APPLICATION NO.	FILING DATE	FIRST NAMED INVENTOR	ATTORNEY DOCKET NO.	CONFIRMATION NO.
10/686,857	10/16/2003	Andrew M. Hiles	HAM-100-A	1733

<p align="center"><b>Advisory Action</b> <b>Before the Filing of an Appeal Brief</b></p>	<p>Application No. 10/686,857</p>	<p>Applicant(s) HILES, ANDREW M.</p>	
	<p>Examiner PAUL T. CHIN</p>	<p>Art Unit 3652</p>

THE REPLY FILED 22 August 2005 FAILS TO PLACE THIS APPLICATION IN CONDITION FOR ALLOWANCE.

NEW

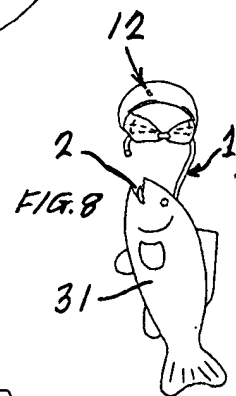
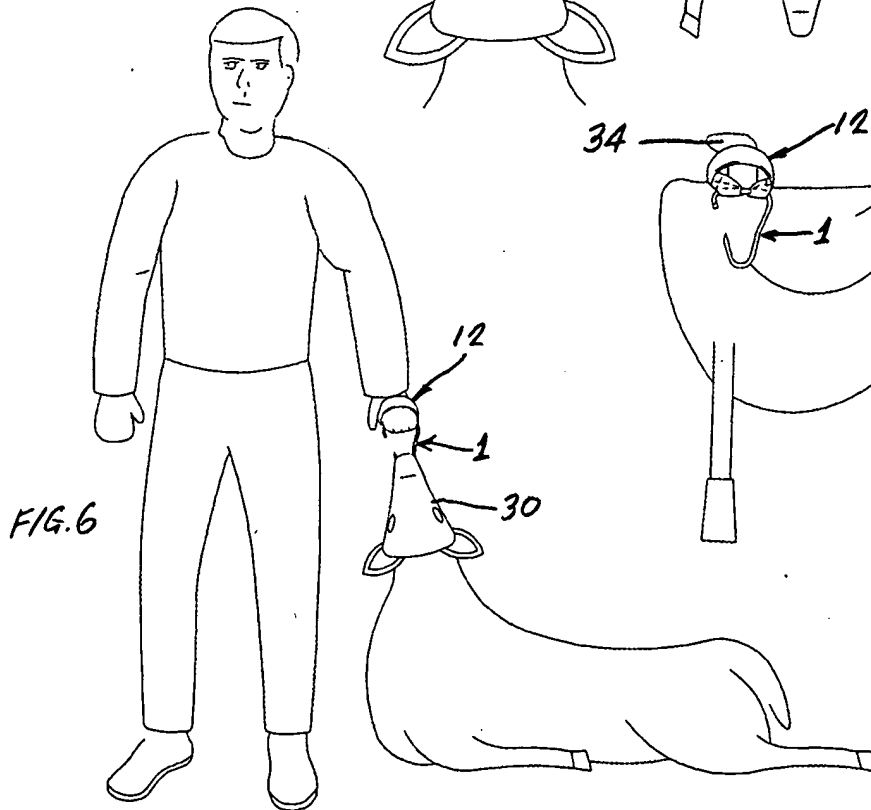
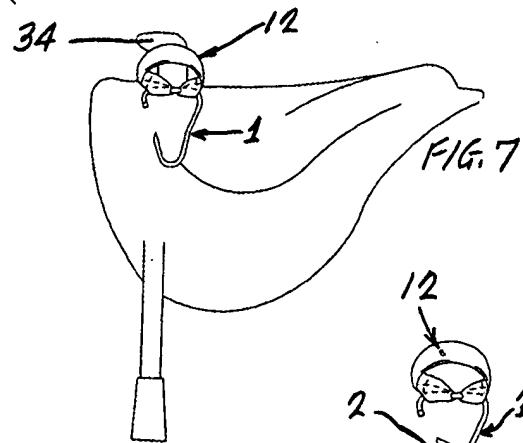
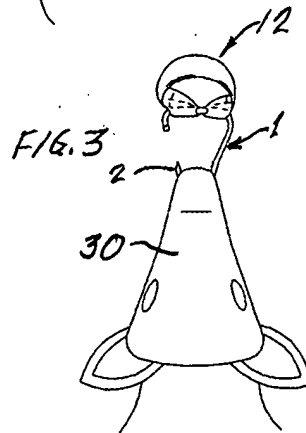
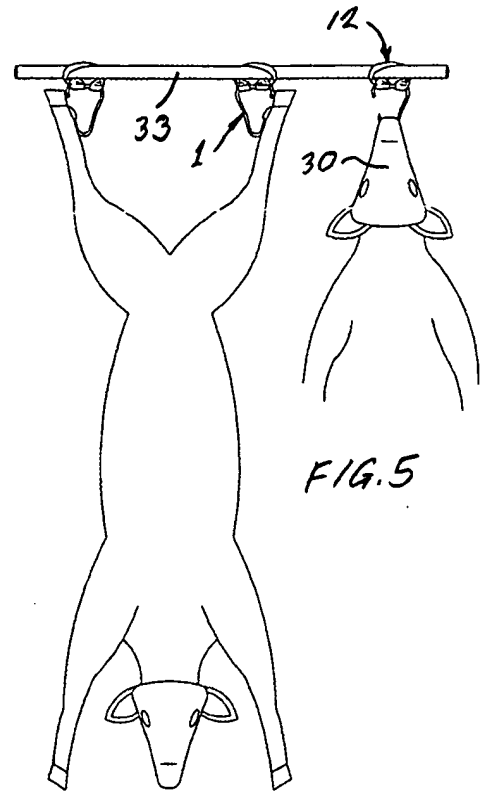
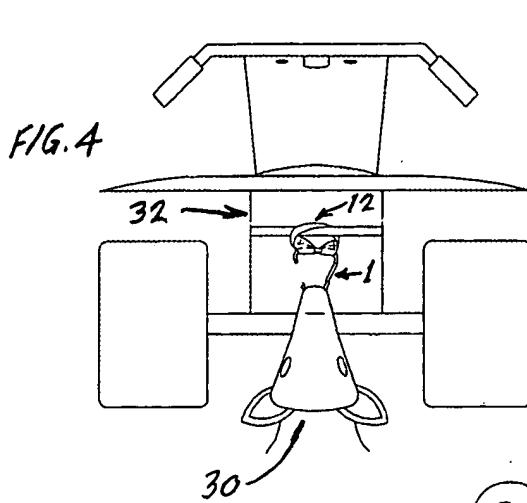
the addition of new limitations in claim 21 and new claim 23 in combination with other structural limitations would require further search and reconsideration of prior art of record. Moreover, applicant proposes to add new drawings 3-8 in the provided amendment. It is pointed out that figures 4 and 6 appear to add new matter in the drawings. In paragraph 28, applicant only describes "the nylon strap member 12 acts as a handle, and also as an attachment to connect the hook member 1 to an ATV". However, applicant proposes to show ATV with a steering and two wheels, which are not originally disclosed in the specification. Further, applicant proposes to show a new figure 6 displaying as to "how the device is distribute the weight of the game to ground requiring little or no lifting", which also is not originally disclosed in the specification. Applicant proposes to add a new paragraph in paragraph 28a reciting as to "how the device is distribute the weight of the game to ground requiring little or no lifting". However, figure 6 shows a user lifting up the device, which is contrary to the statement, i.e. the device distributes the weight of the game to ground requiring no lifting. Therefore, figures 4 and 6 should be withdrawn and the newly provided paragraph [028a] also should be withdrawn. New fiugres 3,5,7, and 8 appear to acceptable.

"Do not  
Enter"  
Disapproved"  
ptc  
9/19/05
